**From:** Amadi, Eric A - DNR  
**Sent:** Tuesday, November 23, 2021 6:25 PM  
**To:** Julie A Zimdars  
**Subject:** FW: BRRTS 02-41-553761 and 06-41-560068 Connell Wabash Site - RAOR Addendum/Pre-Design Work Plan (Rev 2)  
**Attachments:** BRRTS 0241553761 & 0641560068 Connell Wabash RAOR Addendum R2 Sep 28 2021.pdf

Hi Eric – On behalf of Connell Aluminum Properties, attached is the *Addendum (Revision 2) to the Remedial Action Options Report (RAOR) and Pre-Design Sampling Work Plan* for the Former Koppers Tar Plant and Wabash Alloys Site that incorporates WDNR comments received on July 9, 2021.

**Addendum (Revision 2) to Remedial Action Options Report (RAOR)  
and Pre-Design Sampling Work Plan - Connell Aluminum Properties, LLC  
Former Koppers Tar Plant and Wabash Alloys Site  
9100 S. 5<sup>th</sup> Avenue, Oak Creek, WI 53154  
BRRTS# 02-41-553761, FID#241379050  
Connell VPLE BRRTS #:06-41-560068**

**FIGURE 1**  
FIGURE 9 (REV. RAOR REPORT)

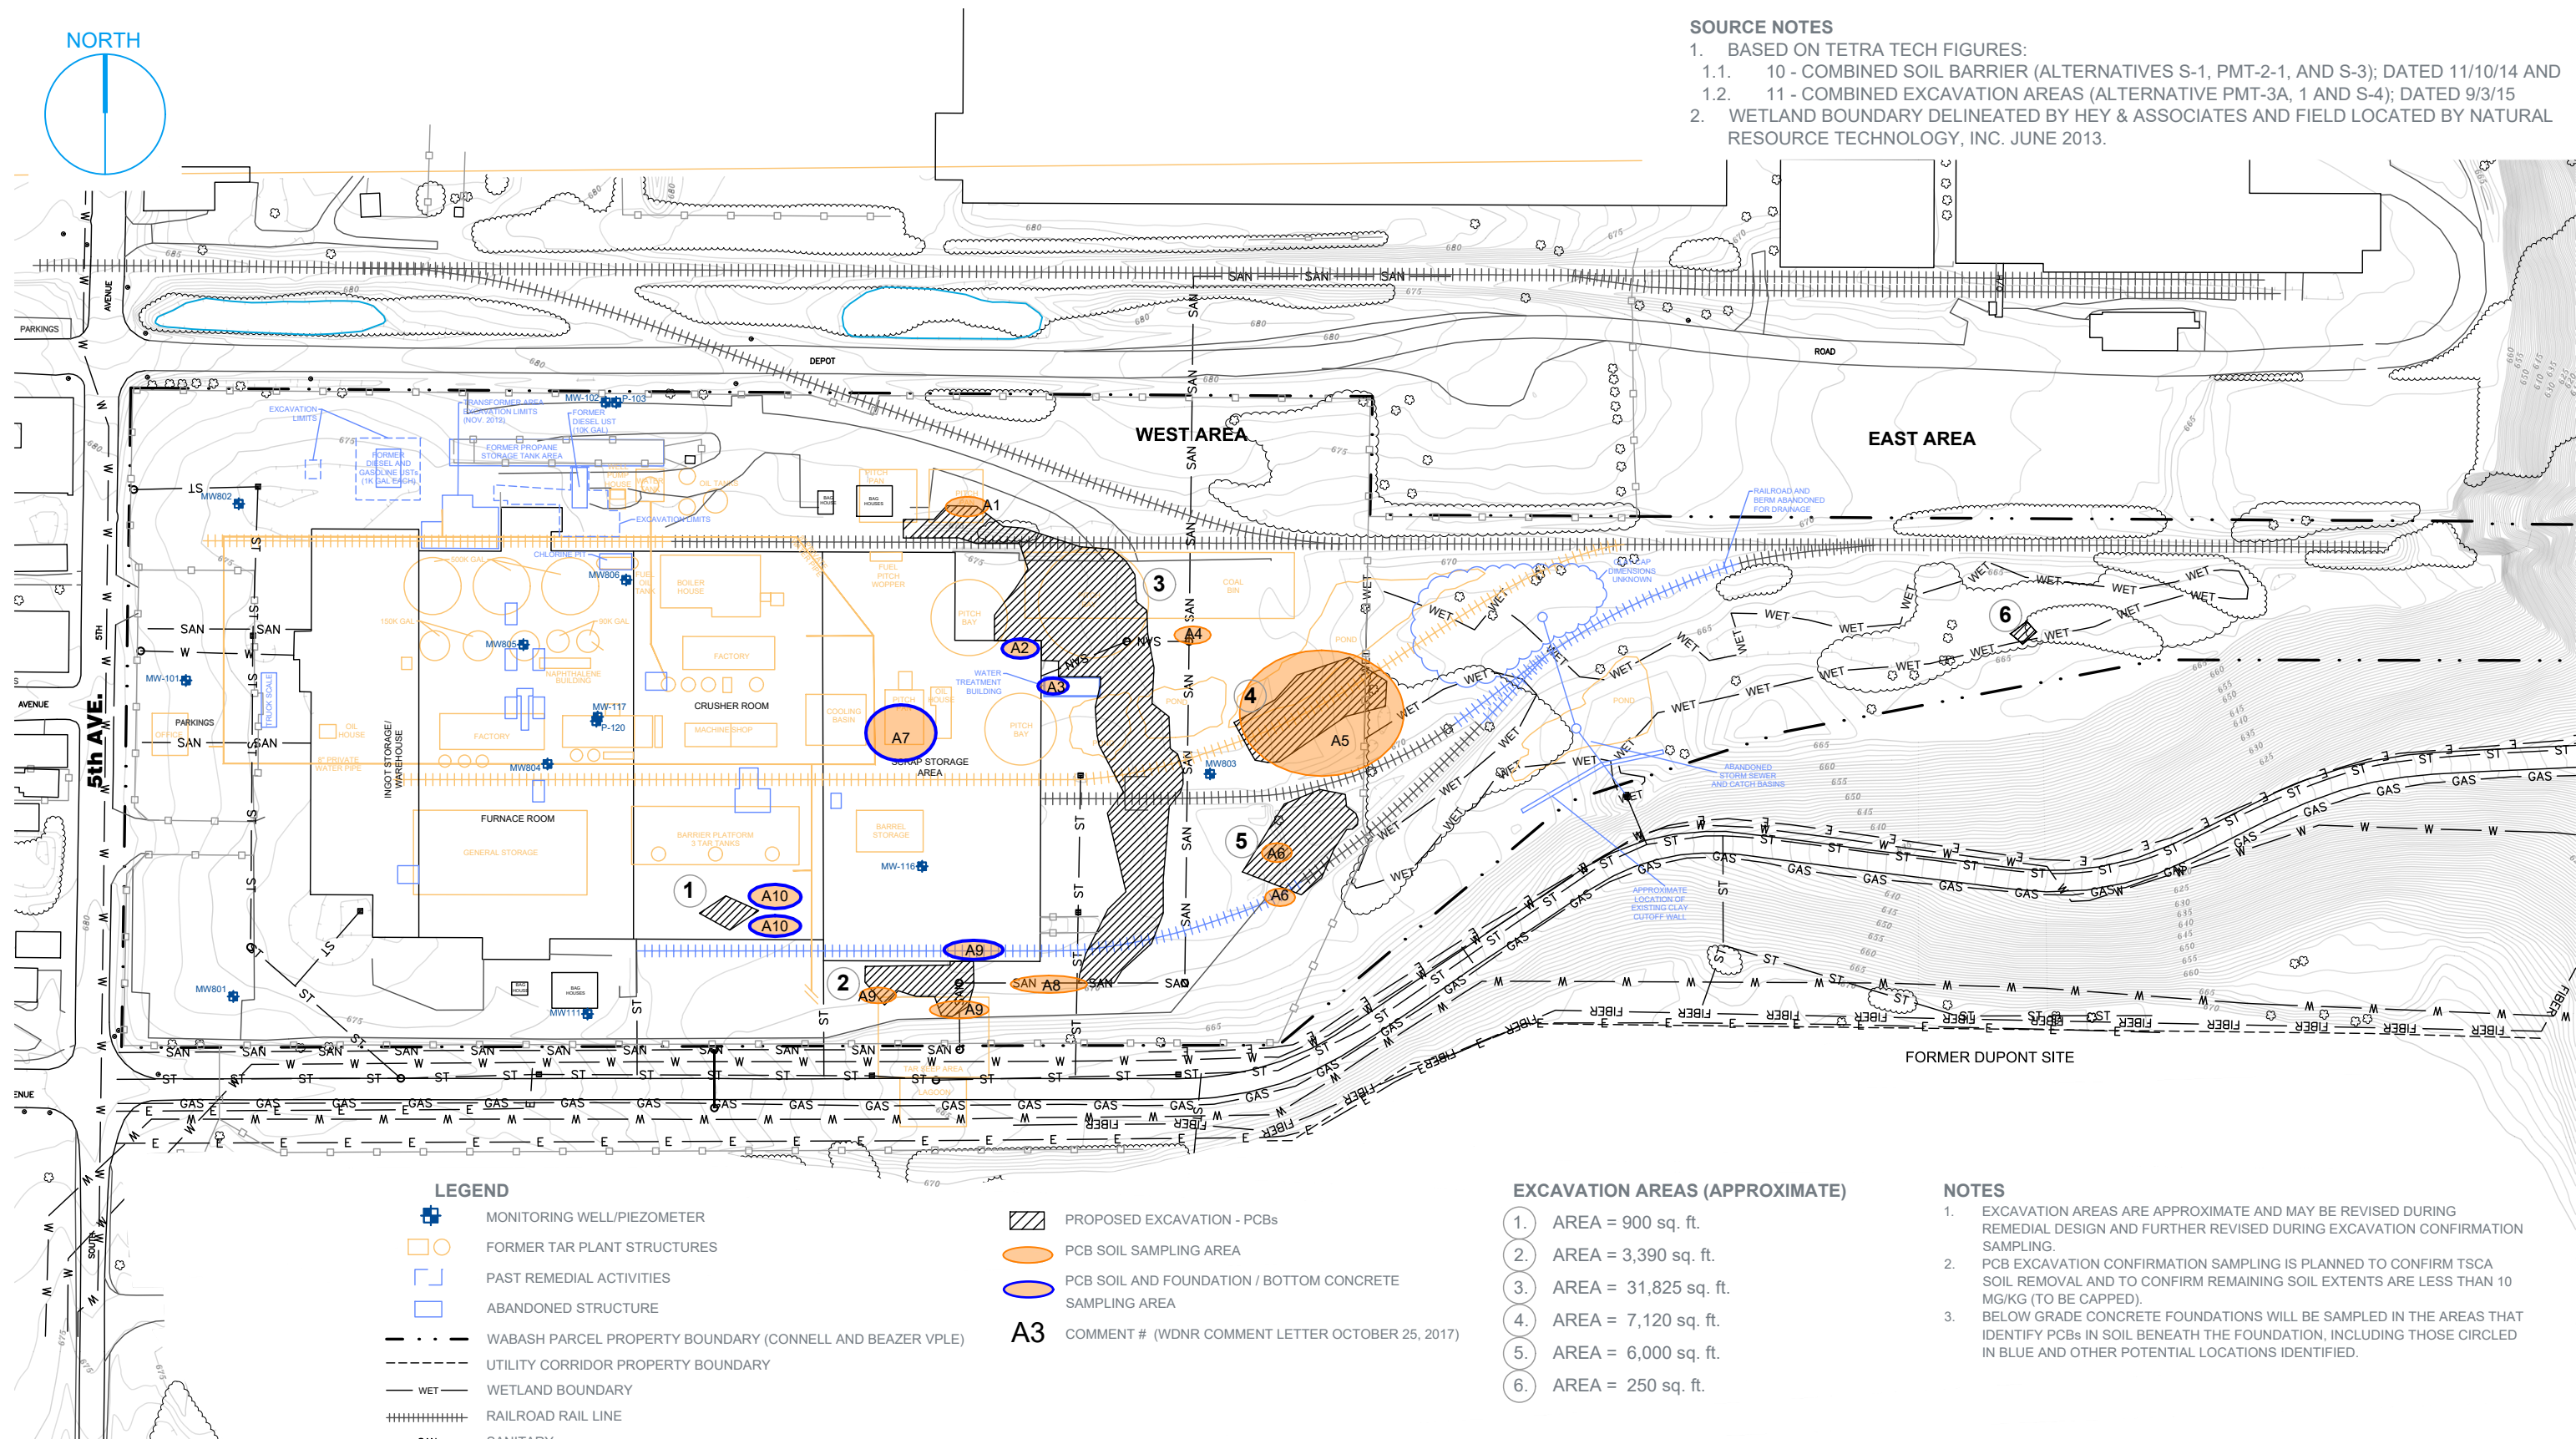
- Figure 1 – Revised RAOR Figure 9 – PCB Soil Excavation and Disposal (Alternative S-4) for purposes of showing all 6 planned excavation areas (Western Areas 1 through 5 and Eastern Area 6) and showing all 10 locations by comment number (A1 through A10) that WDNR identified as additional PCB sampling locations. Note 1 was revised and Notes 2 and 3 were added to include notes about the planned excavation confirmation sampling and sampling of the below grade concrete foundations where PCBs are identified in soil.

**FIGURE 2**  
**FIGURE C40 (REV. SI REPORT)**

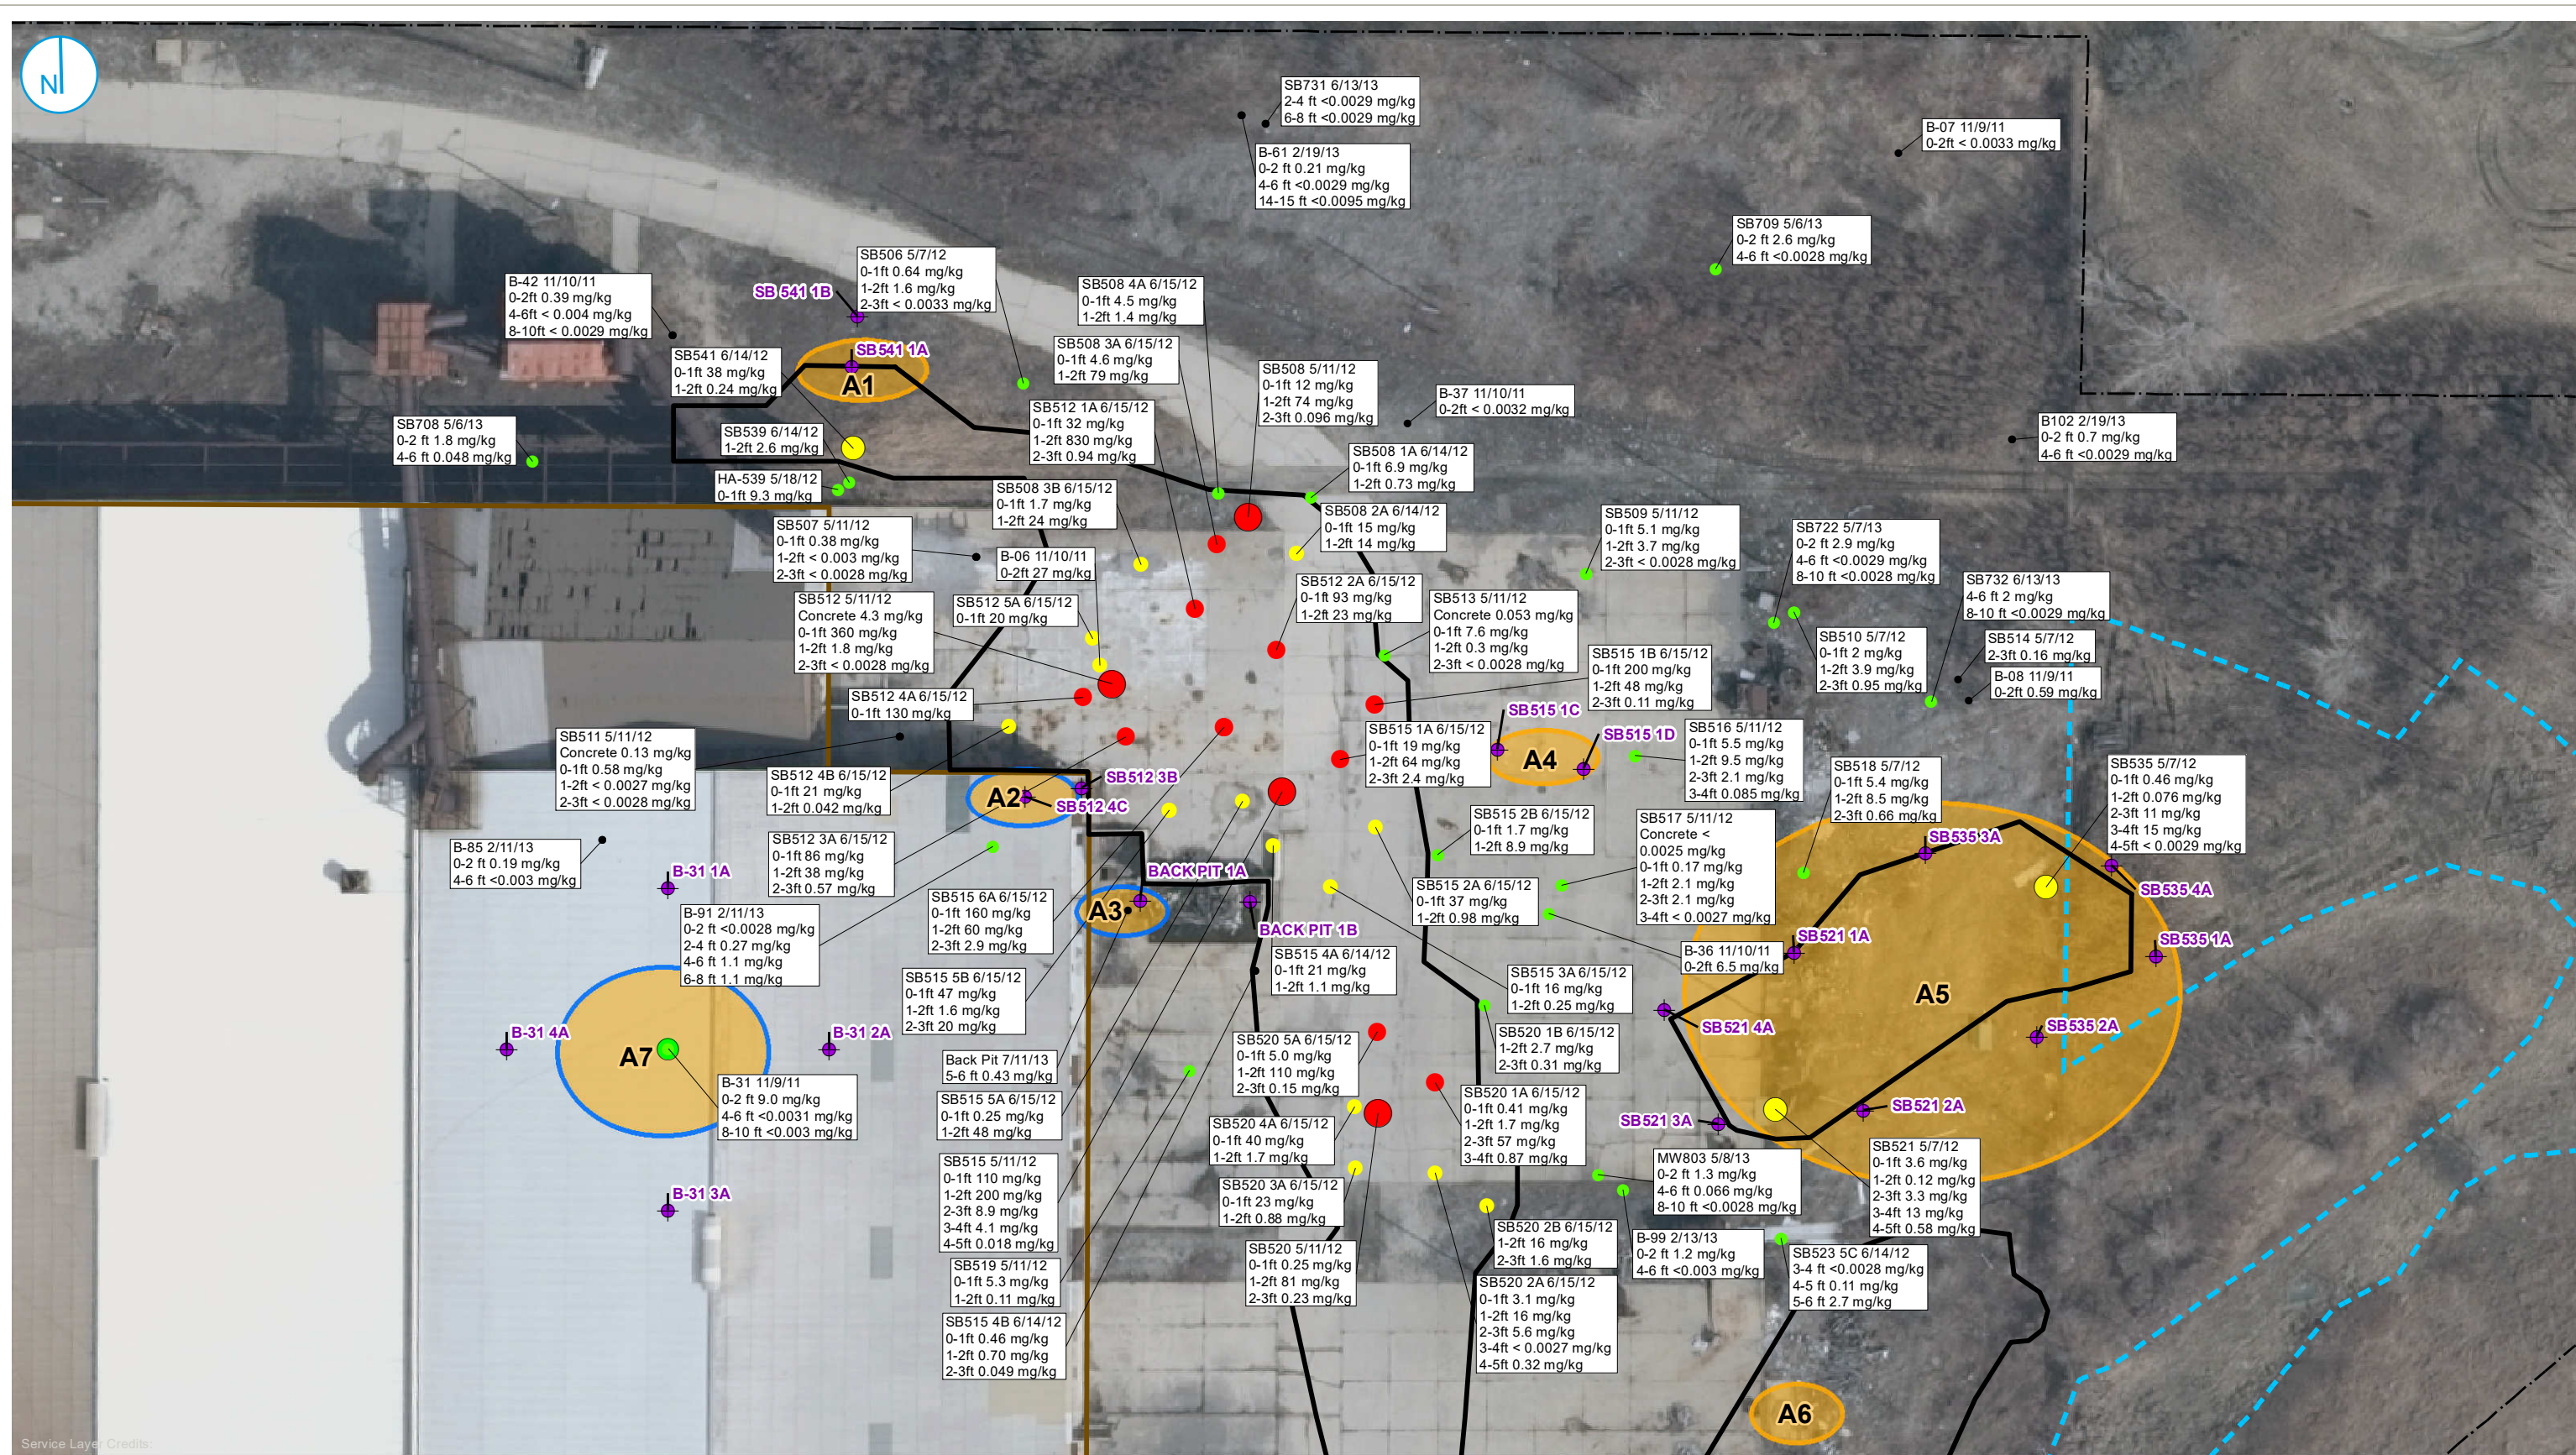
- Figure 2 – Revised Figure C40 SI Report - PCB Soil Data – North Yard TSCA Area for purposes of showing more specifically the additional PCB sampling locations related to comments A1 through A5, and A7.
